MEETING DATE:	February 10, 2022
DATE DELIVERED:	February 8, 2022
AGENDA ITEM NO.:	26
CAPTION:	Project No. 52934 – Review of Rules Adopted by the Independent Organization
DESCRIPTION:	Memo and Proposed Order

RE: February 10, 2022 Open Meeting – Item No. 26
Project No. 52934 – *Review of Rules Adopted by the Independent Organization (Discussion and possible action)*

NOGRR Number	<u>235</u>	NOGRR Title	Combining Greyboxes and Other Corrections
Date of Decision	January 31, 2022		
Action	Recommended Approval		
Timeline	Normal		
Proposed Effective Date	March 1, 2022		
Priority and Rank Assigned	Not Applicable		
Nodal Operating Guide Sections Requiring Revision	2.9.1, Additional Voltage Ride-Through Requirements for Intermittent Renewable Resources 3.3.2.1, Corrected Until Reactive Limits (CURL) 6.1.3.3, Data Recording and Redundancy Requirements		
Related Documents Requiring Revision/Related Revision Requests	None		
Revision Description	This Nodal Operating Guide Revision Request (NOGRR) is submitted for transparency purposes to make small corrections to language associated with NOGRR210, Related to NPRR1005, Clarify Definition of Point of Interconnection (POI) and Add Definition Point

Figure 1: Default Voltage Ride-Through Boundaries for IRRs Connected to the ERCOT Transmission Grid

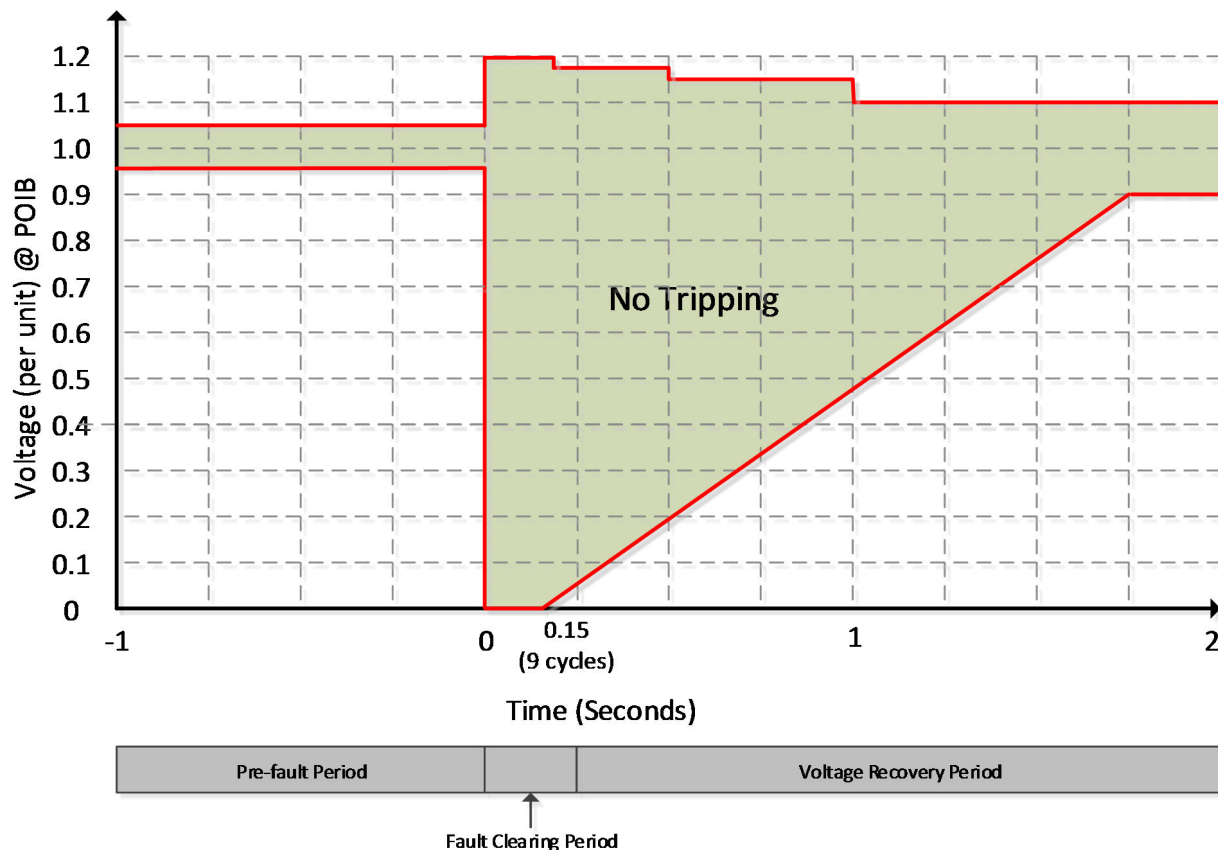
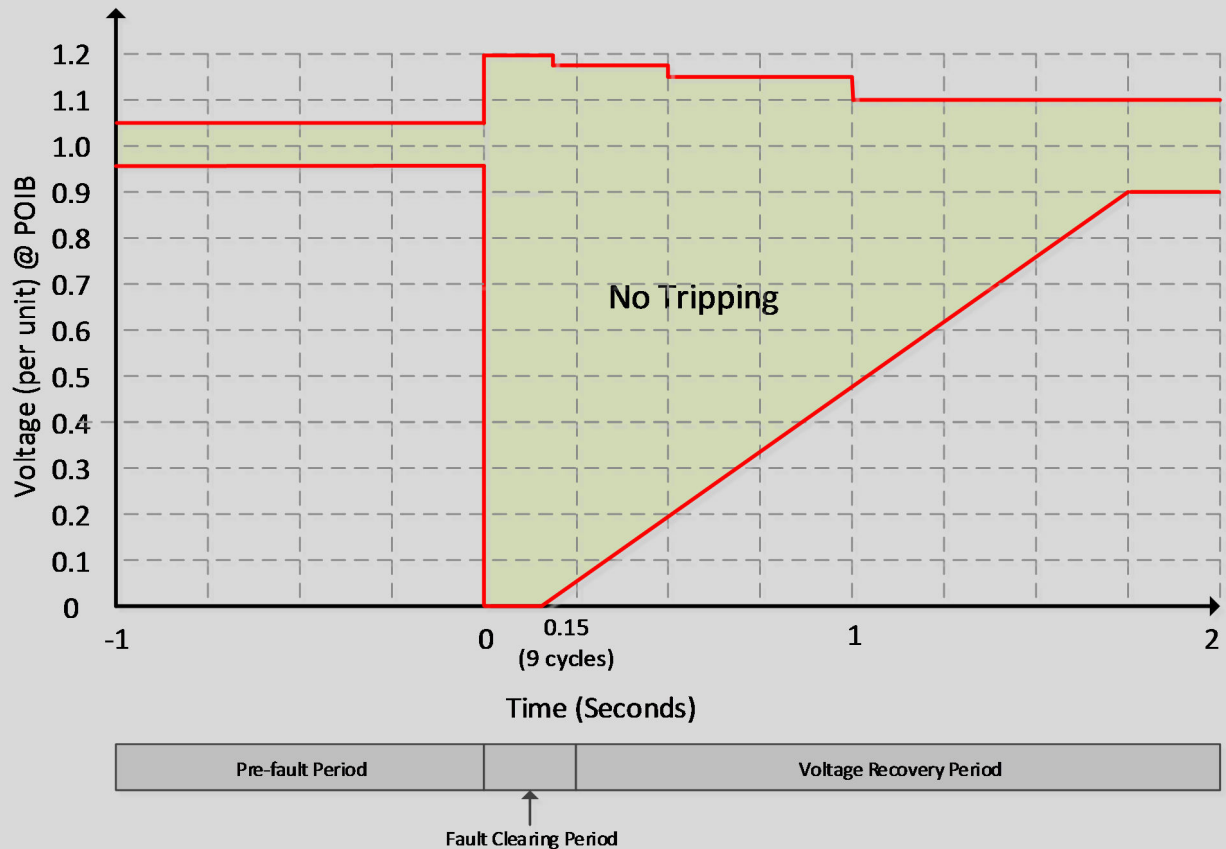
- (3) Each IRR is required to set generator voltage relays to remain in service for at least 0.15 seconds during all transmission faults and to allow the system to recover as illustrated in Figure 1, Default Voltage Ride-Through Boundaries for IRRs Connected to the ERCOT Transmission Grid, below. Recovery time to 90% of per unit voltage should be within 1.75 seconds. Faults on individual phases with delayed clearing (zone 2) may result in phase voltages outside this boundary but if the phase voltages remain inside this boundary, then generator voltage relays are required to be set to remain connected and recover as illustrated in Figure 1.

- (5) Each IRR shall set generator voltage relays to remain interconnected to the ERCOT System during the following high-voltage conditions, as illustrated in Figure 1: any per-unit voltage equal to or greater than 1.175 but less than 1.2 for up to 0.2 seconds, any per-

[NOGRR204: Replace Section 2.9.1 above with the following upon system implementation of NPRR989:]

- (3) Each IRR or ESR is required to set its voltage relays to remain in service for at least 0.15 seconds during all transmission faults and to allow the system to recover as illustrated in Figure 1, Default Voltage Ride-Through Boundaries for IRRs and ESRs Connected to the ERCOT Transmission Grid, below. Recovery time to 90% of per unit voltage should be within 1.75 seconds. Faults on individual phases with delayed clearing (zone 2) may result in phase voltages outside this boundary but if the phase voltages remain inside this boundary, then Resource voltage relays are required to be set to remain connected and recover as illustrated in Figure 1.

- (5) Each IRR or ESR shall set its voltage relays to remain interconnected to the ERCOT System during the following high-voltage conditions, as illustrated in Figure 1: any per-unit voltage equal to or greater than 1.175 but less than 1.2 for up to 0.2 seconds, any per-unit voltage equal to or greater than 1.15 but less than 1.175 per unit voltage for up to 0.5 seconds, and any per-unit voltage equal to or greater than 1.1 but less than 1.15 for up to 1.0 seconds. The indicated voltages are measured at the POIB.

Figure 1: Default Voltage Ride-Through Boundaries for IRRs and ESRs Connected to the ERCOT Transmission Grid
